2023 Oregon Residential Specialty Code Adoption

Department of Consumer and Business Services

Summary of amendments to the base code

Effective: Oct. 1, 2023

**FIGURE R301.2.2.6(1)
BRACED WALL PANELS OUT OF PLANE**

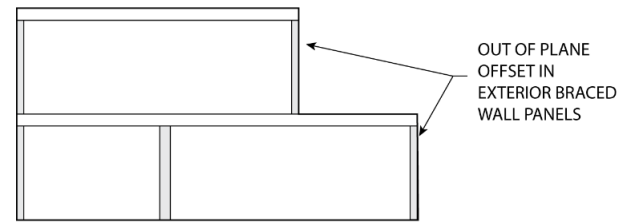
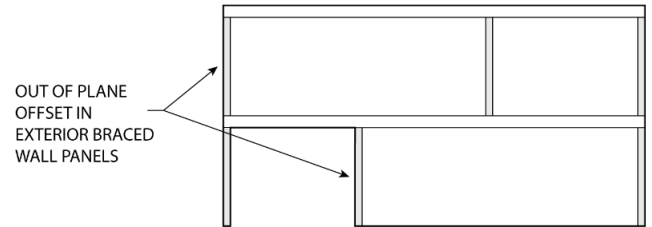
Section R301.2.2.6 – Oregon adds figures to clarify the associated provisions. New amendments clarifying engineering requirements.

Conditions where exterior *shear wall* lines or *braced wall panels* are not in one plane vertically from the foundation to the uppermost story in which they are required. [See Figure R301.2.2.6\(1\).](#)

**FIGURE R301.2.2.6(2)
BRACED WALL PANELS SUPPORTED BY
CANTILEVER OR SETBACK**

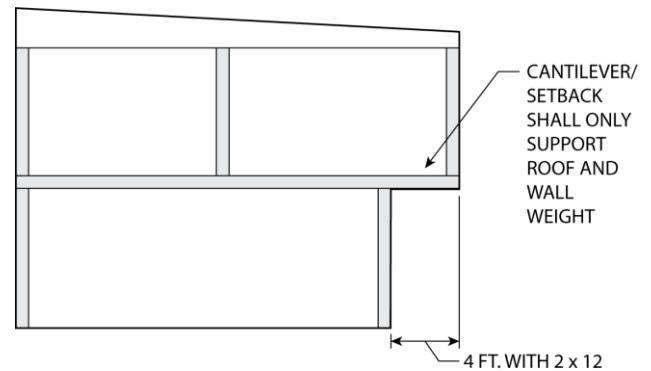
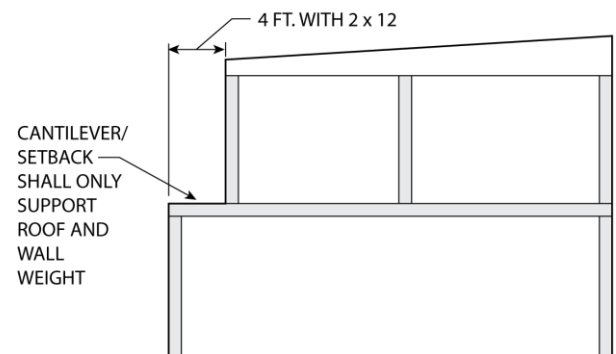
Exception: For wood *light-frame construction*, floors with cantilevers or setbacks not exceeding four times the nominal depth of the wood floor joists [\[see Figure R301.2.2.6\(2\)\]](#) are permitted to support *braced wall panels* that are out of plane with *braced wall panels* below provided that all of the following are satisfied:

FIGURE R301.2.2.6(3)
FLOOR OR ROOF NOT SUPPORTED AT ALL EDGES

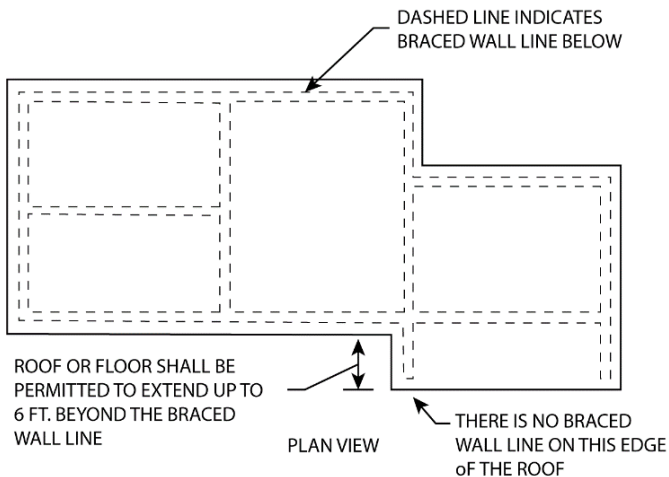
2. **Lateral support of roofs and floors.** Conditions where a section of floor or roof is not laterally supported by *shear walls* or *braced wall lines* on all edges. [See Figure R301.2.2.6\(3\).](#)

FIGURE R301.2.2.6(4)
FLOOR OR ROOF EXTENSION BEYOND BRACED WALL LINE

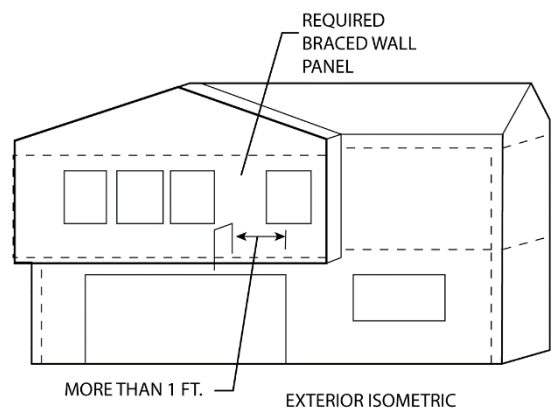
Exception: Portions of floors that do not support *shear walls*, *braced wall panels* above, or roofs shall be permitted to extend not more than 6 feet (1829 mm) beyond a *shear wall* or *braced wall line*. [See Figure R301.2.2.6\(4\).](#)

FIGURE R301.2.2.6(5)
BRACED WALL PANEL EXTENSION OVER OPENING

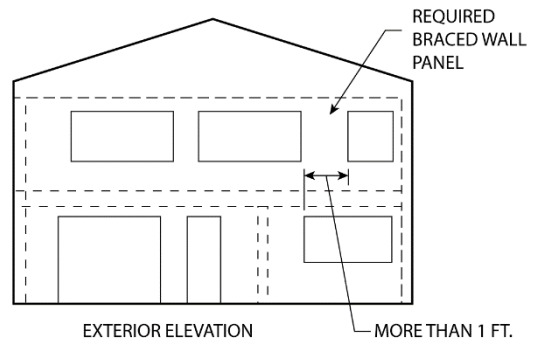
3. **Shear wall or braced wall offsets in plane.** Conditions where the end of a *braced wall panel* occurs over an opening in the wall below and extends more than 1 foot (305 mm) horizontally past the edge of the opening. This provision is applicable to *shear walls* and *braced wall panels* offset in plane and to *braced wall panels* offset out of plane in accordance with the exception to Item 1. [See Figure R301.2.2.6\(5\).](#)

FIGURE R301.2.2.6(6)
OPENING LIMITATIONS FOR FLOOR AND ROOF DIAPHRAGMS

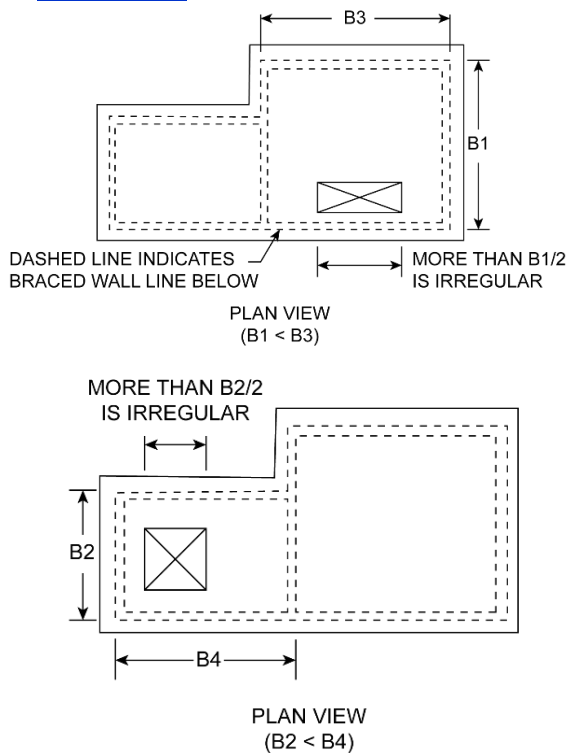
4. **Floor and roof opening.** Conditions where an opening in a floor or roof exceeds the lesser of 12 feet (3658 mm) or 50 percent of the least floor or roof dimension between adjacent braced wall lines. See [Figure R301.2.2.6\(6\)](#).

FIGURE R301.2.2.6(7)
PORTIONS OF FLOOR LEVEL OFFSET VERTICALLY

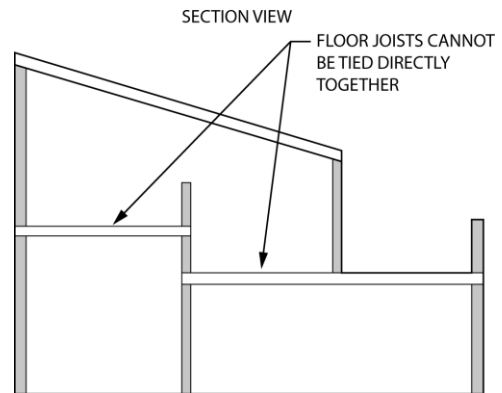
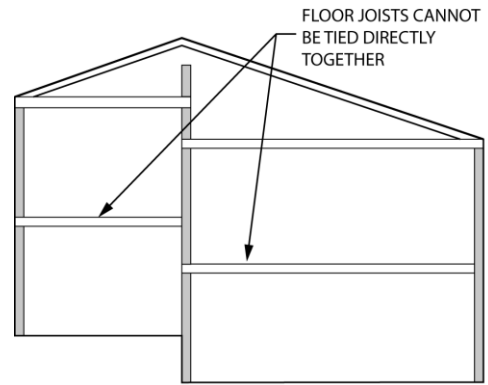
1. Framing supported directly by continuous foundations at the perimeter of the building.
2. For wood *light-frame construction*, floors shall be permitted to be vertically offset where the floor framing is lapped or tied together as required by Section R502.6.1. See [Figure R301.2.2.6\(7\)](#).

FIGURE R301.2.2.6(8)
BRACED WALL LINES NOT PERPENDICULAR

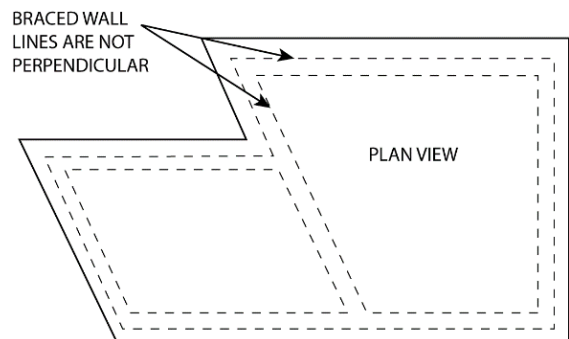
6. **Perpendicular shear wall and wall bracing.** Conditions where *shear walls* and *braced wall lines* do not occur in two perpendicular directions. See [Figure R301.2.2.6\(8\)](#).
